ADDENDUM NUMBER TWO (2)

**2018 BOND PROJECT: RESTROOM IMPROVEMENTS FOR
LANIER HIGH SCHOOL**

JACKSON PUBLIC SCHOOL DISTRICT
JACKSON, MISSISSIPPI

January 17, 2020

1 ENLARGED PLAN "BASE BID"
P401 1/4" = 1'-0"

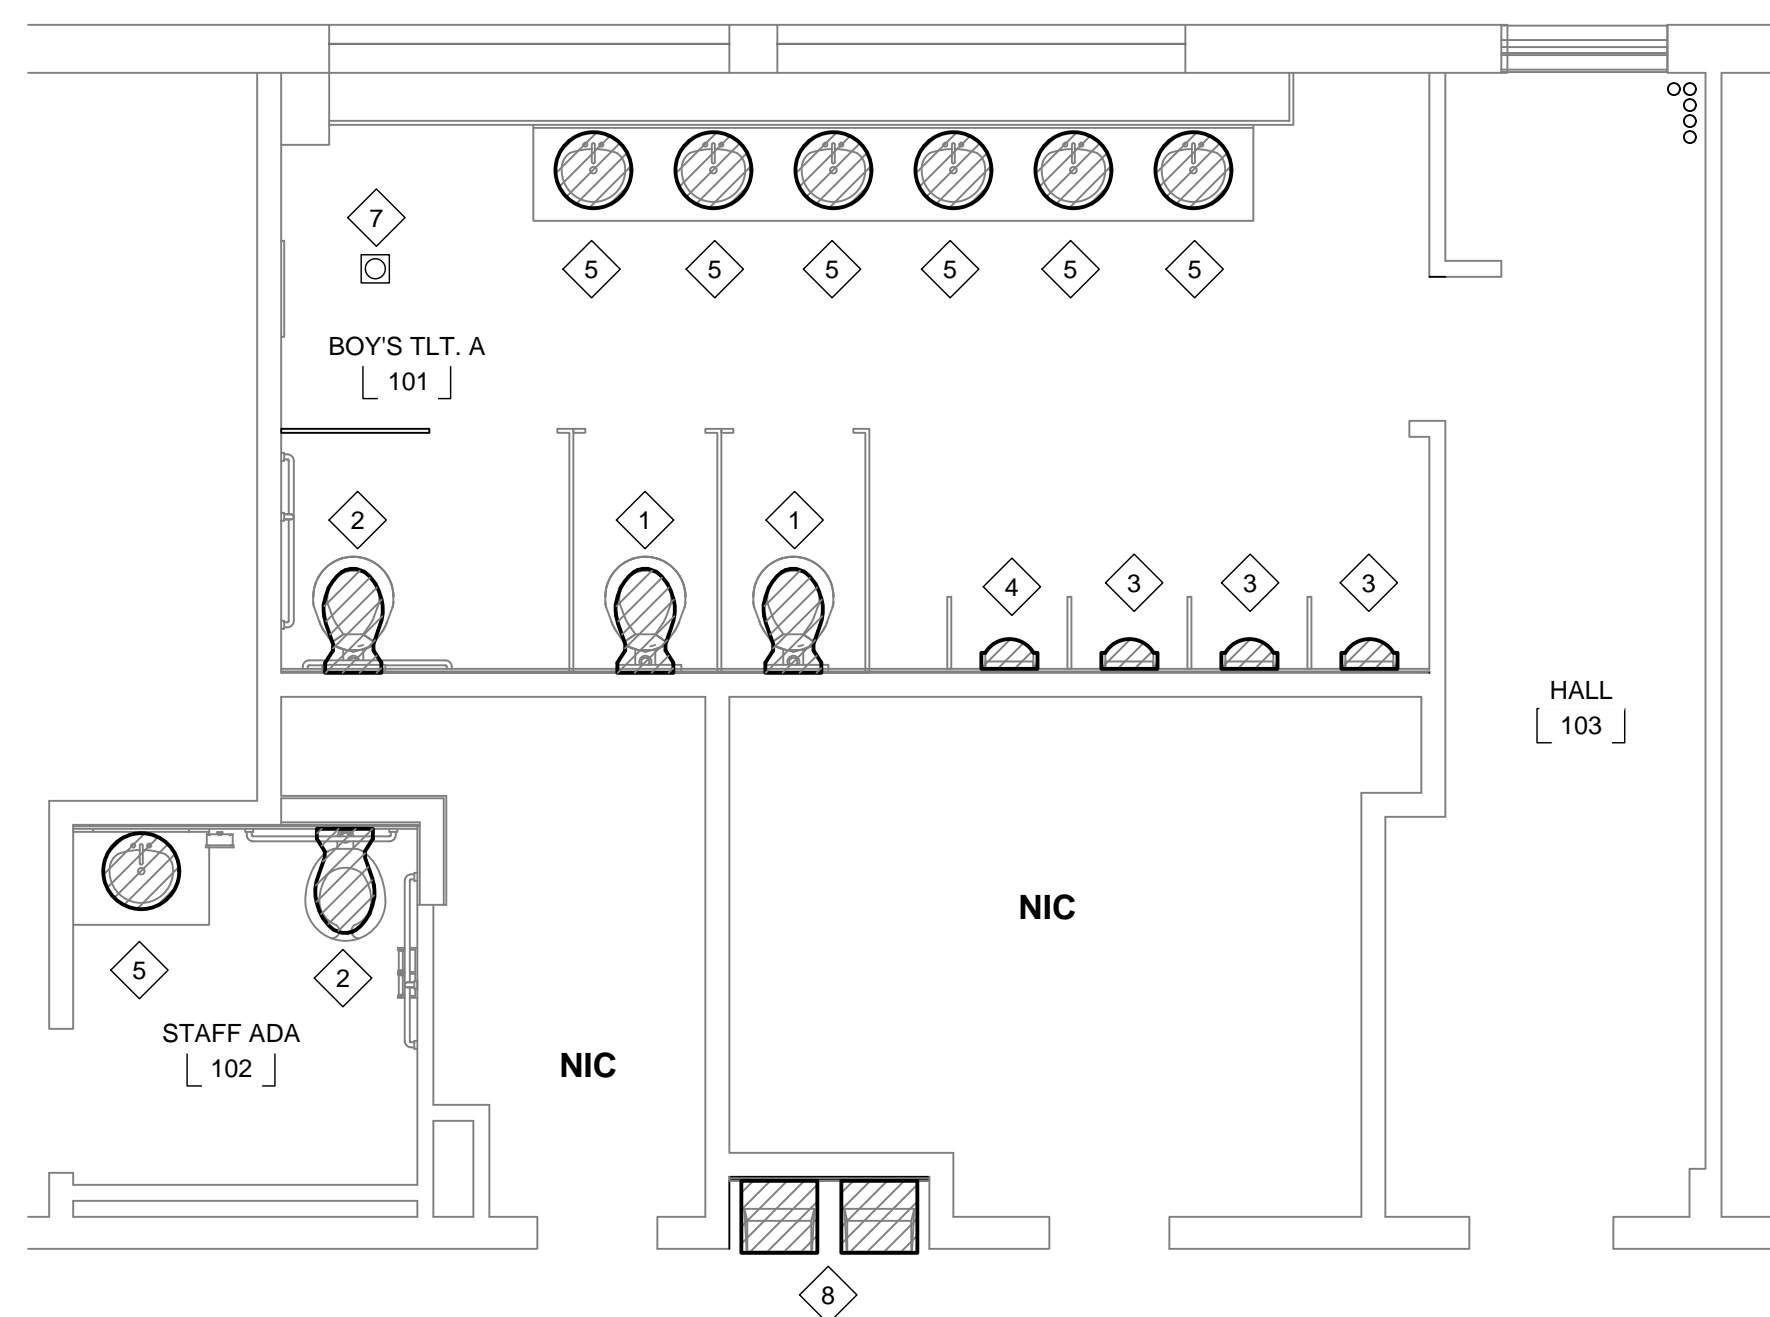
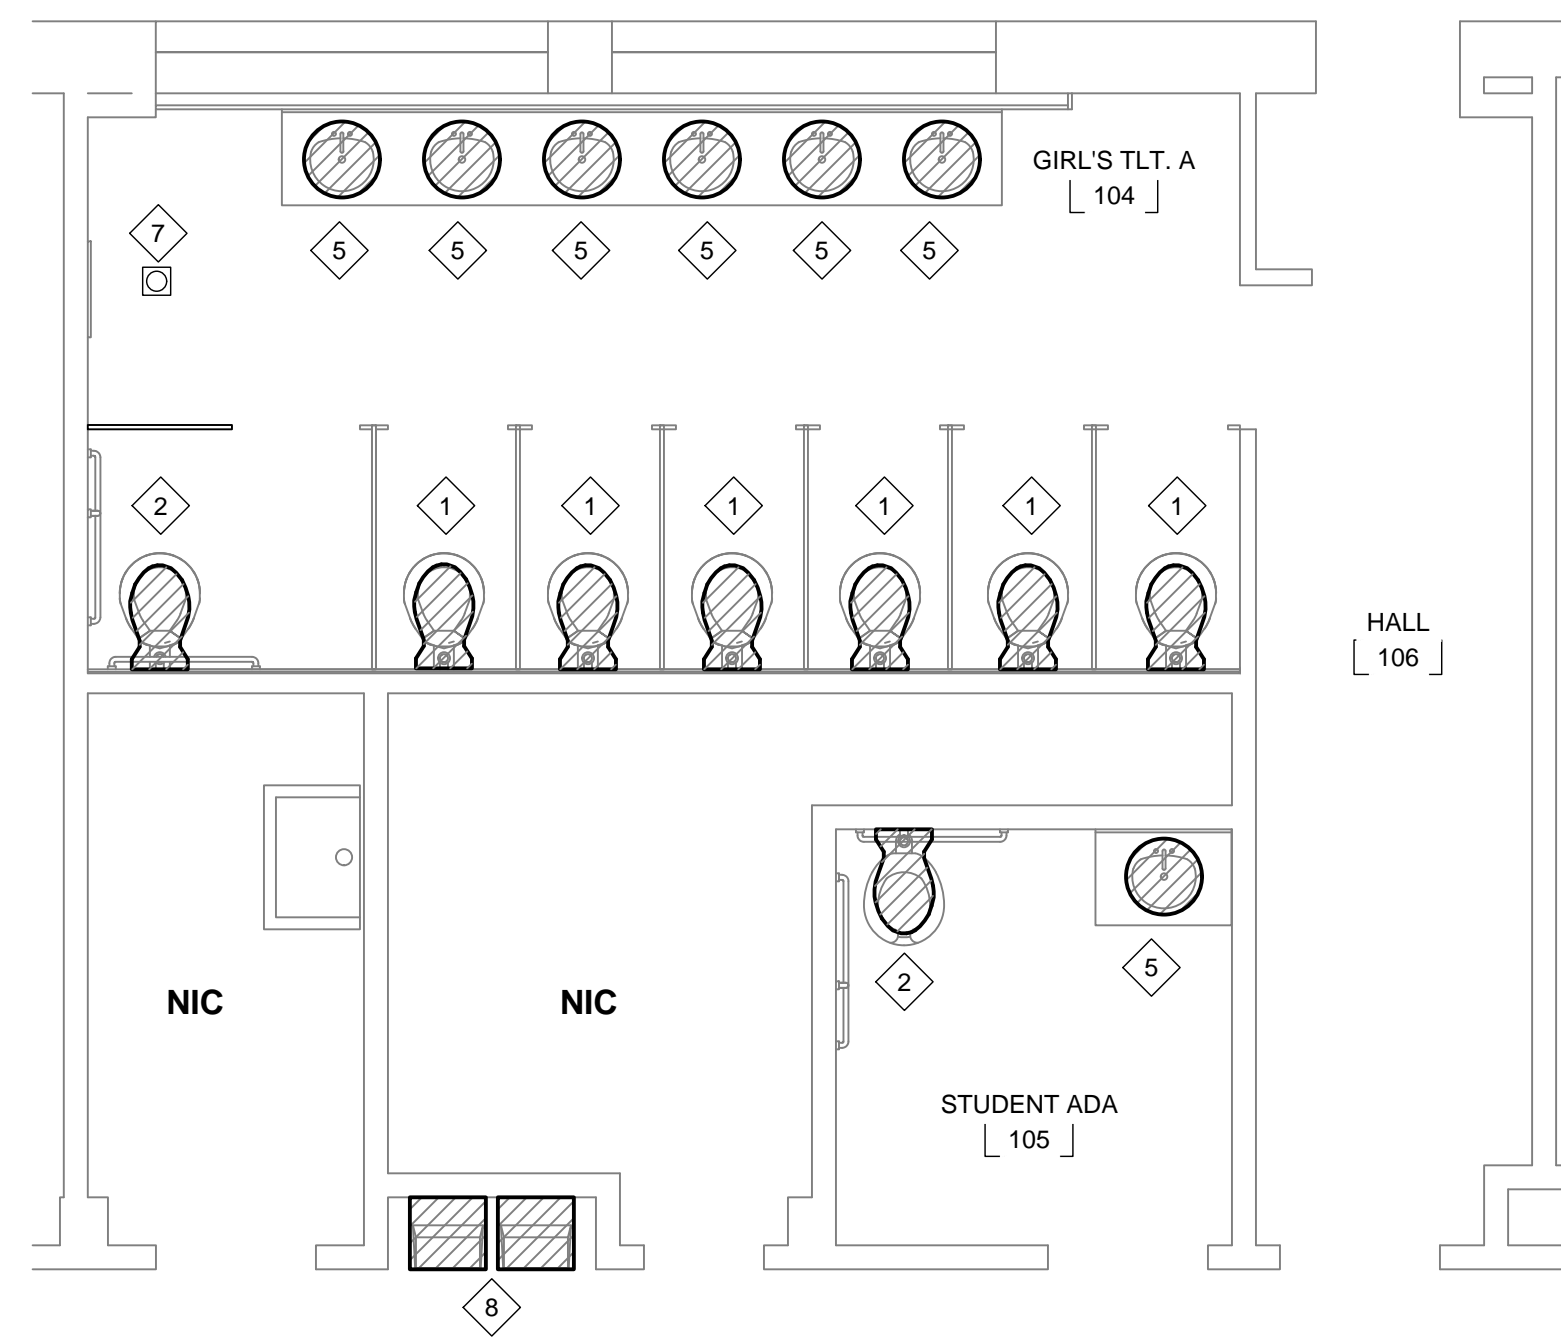
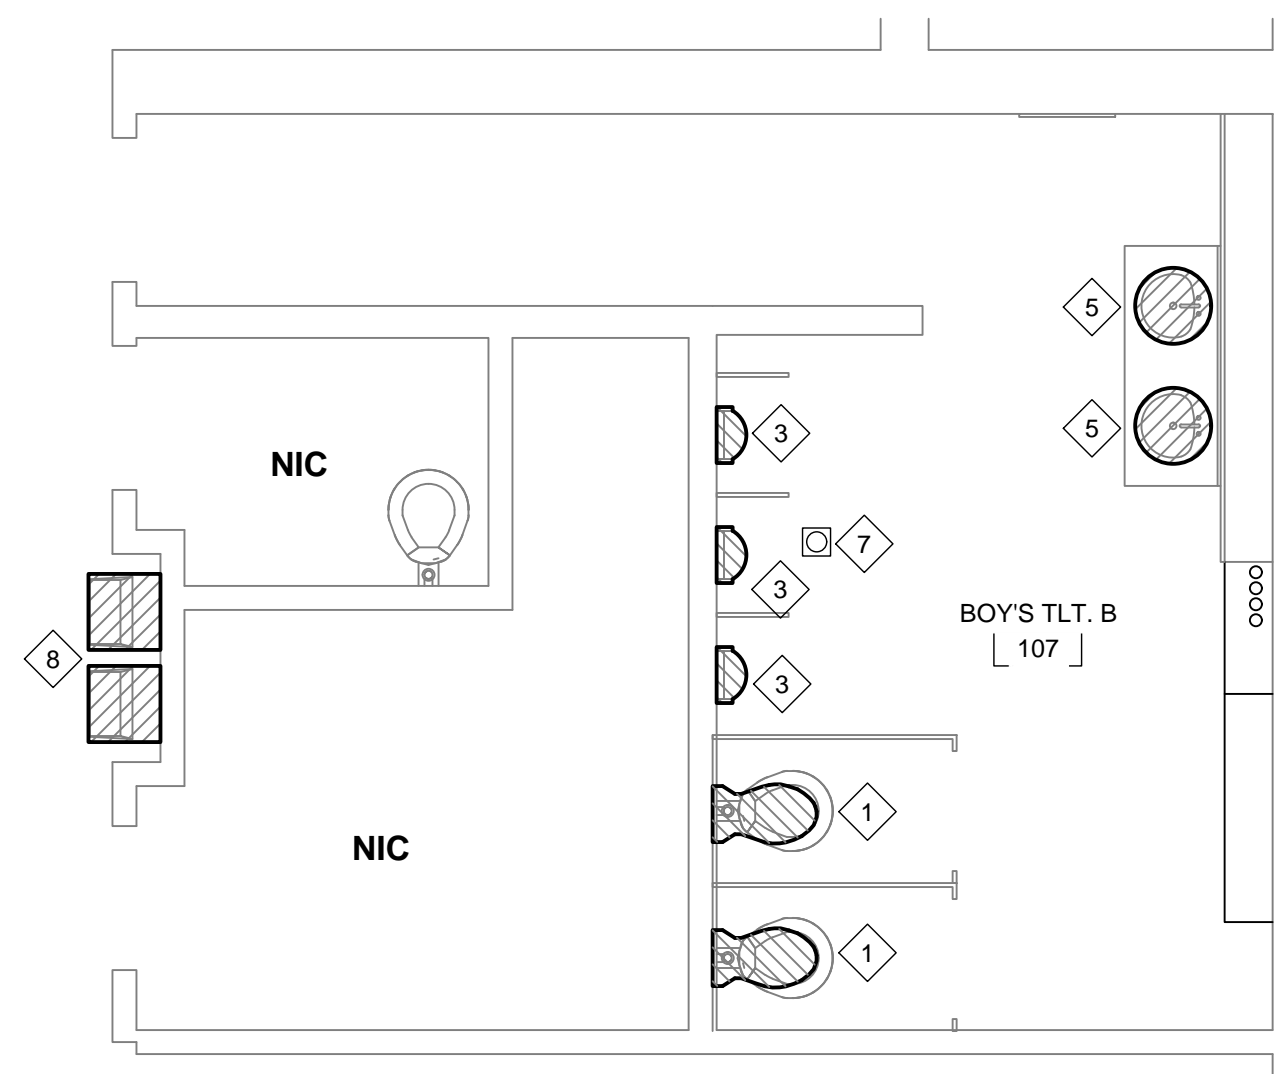
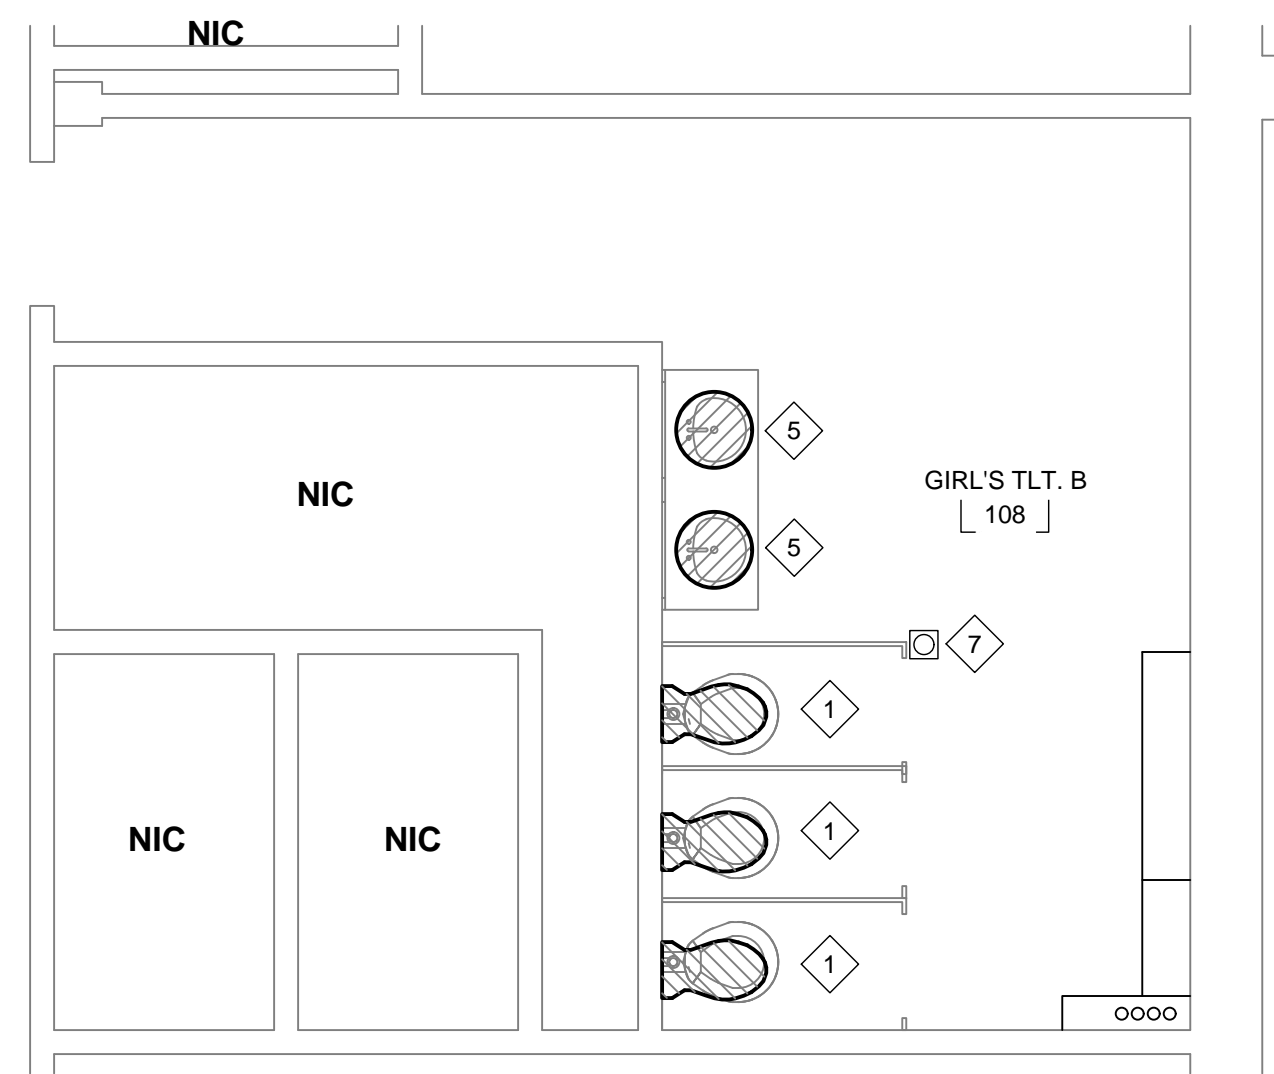
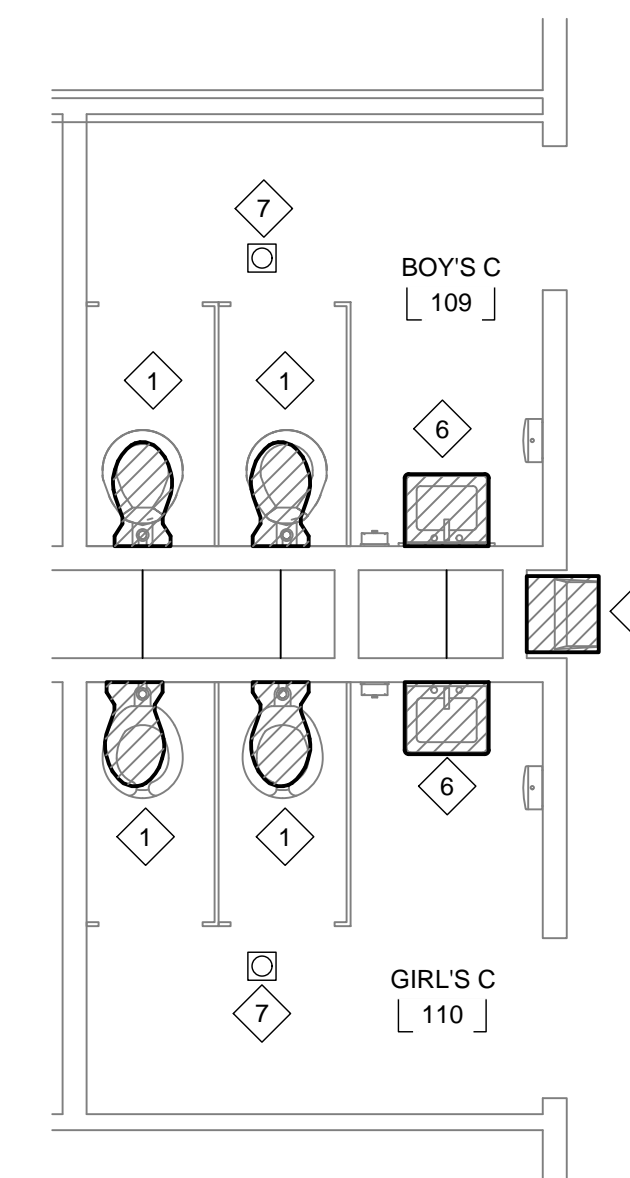
ADDENDUM #2: 01-10-20
1. INDICATED WHAT IS BASE BID AND WHAT IS ADD ALTERNATE #1.

1 ENLARGED SECOND FLOOR PLAN "BASE BID"
P402 1/4" = 1'-0"

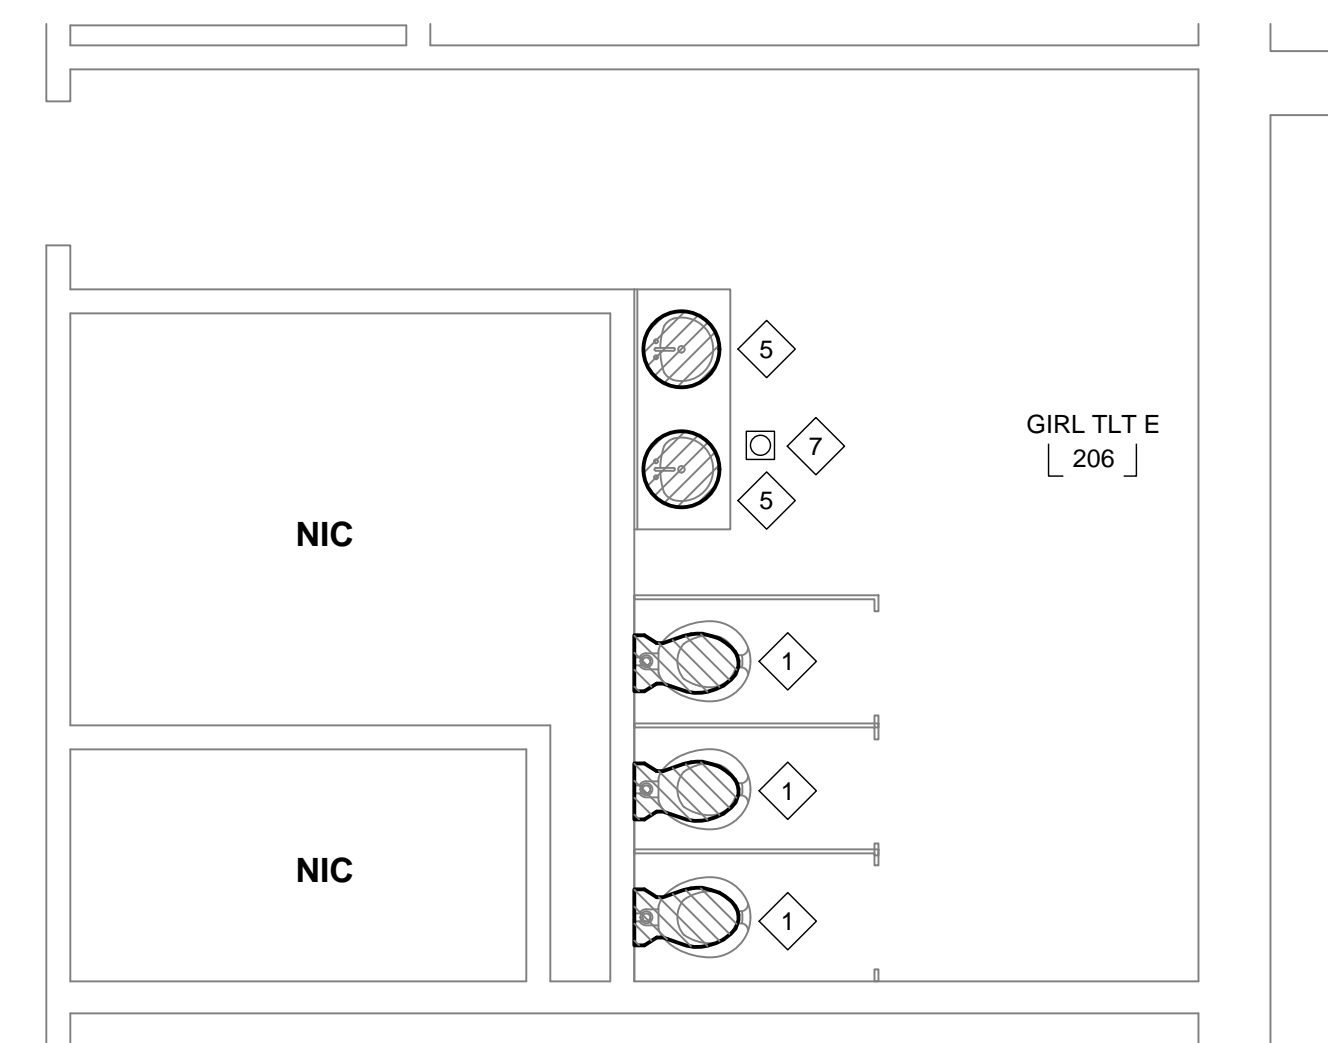
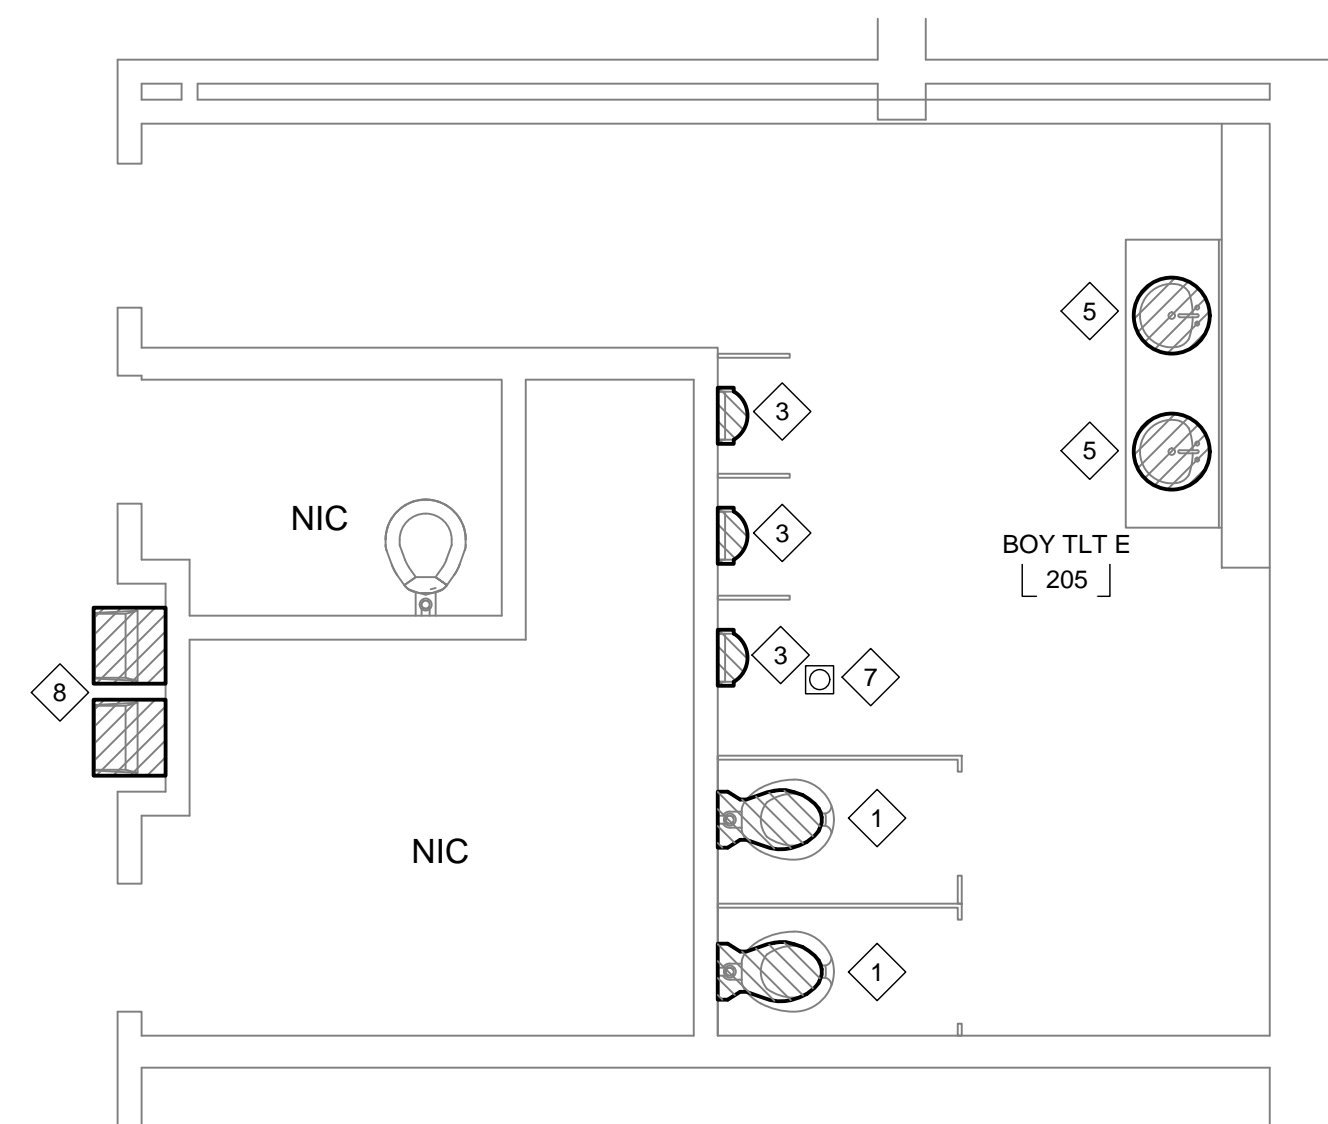
ADDENDUM #2: 01-10-20
1. INDICATED WHAT IS BASE BID AND WHAT IS ADD ALTERNATE #1.
